**ROYAL BOROUGH OF  
KENSINGTON AND  
CHELSEA**

**LATE UPDATE**

PP/02/01324

**SUBMISSION OF DETAILS OF A SCHEME FOR THE TREATMENT OF CHELSEA CREEK PURSUANT TO CONDITION 12 OF PLANNING PERMISSION PP/02/01324 GRANTED BY THE SECRETARY OF STATE ON 30 JANUARY 2006.**

**RIVER WALLS  
PACKAGE 2:  
DETAIL OF  
BOAT-LANDING ACCESS**

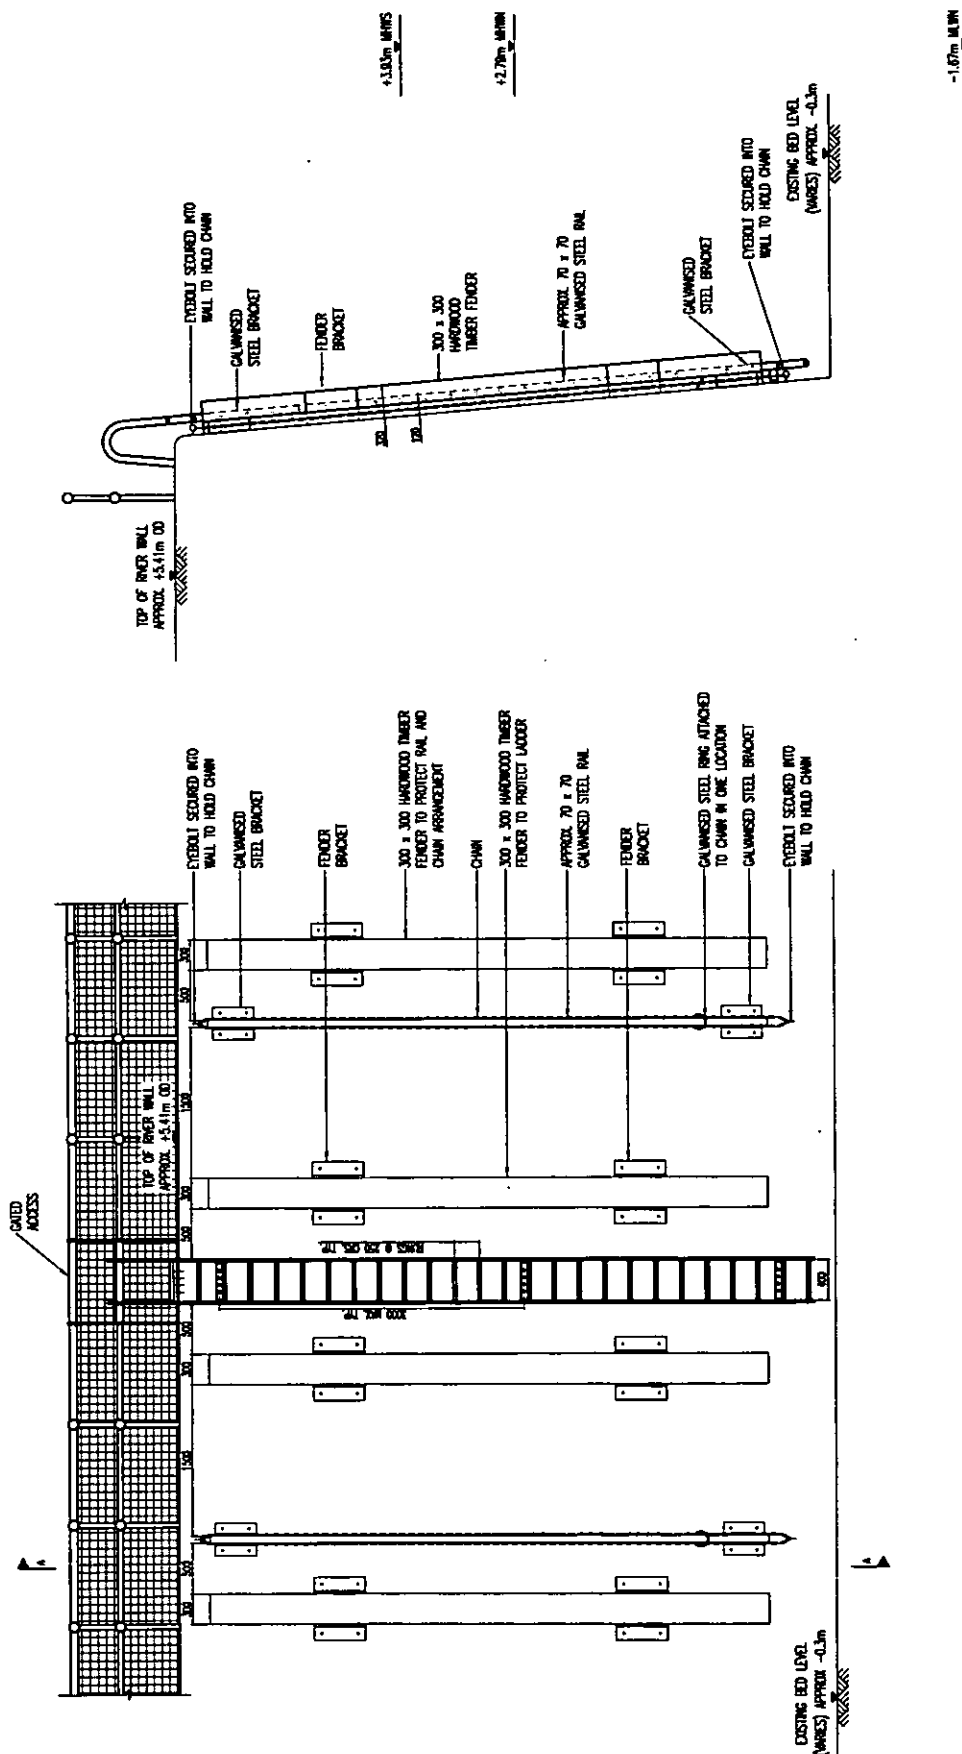
We request that drawings are submitted to show a boating landing pontoon to be accommodated within a gap in the terraces adjacent to the crescent shaped park. We are happy to advise on the design of the pontoon.

As discussed in our earlier telephone conversation please find attached the updated drawing taking account of your latest comments and combining this with a 5m boat requirement as previously indicated by Peter Makower (member of West London River Group). Further fenders outside of the risers have been provided as you have suggested.

Thank you for sending through the revised drawing - titled River Walls Package 2: Detail of Boat-Landing Access dated 27/06/08 Revision 3. We can confirm that we are satisfied with the revised drawing. We also commend you on your efforts to ensure that it best meets the needs of the river users.
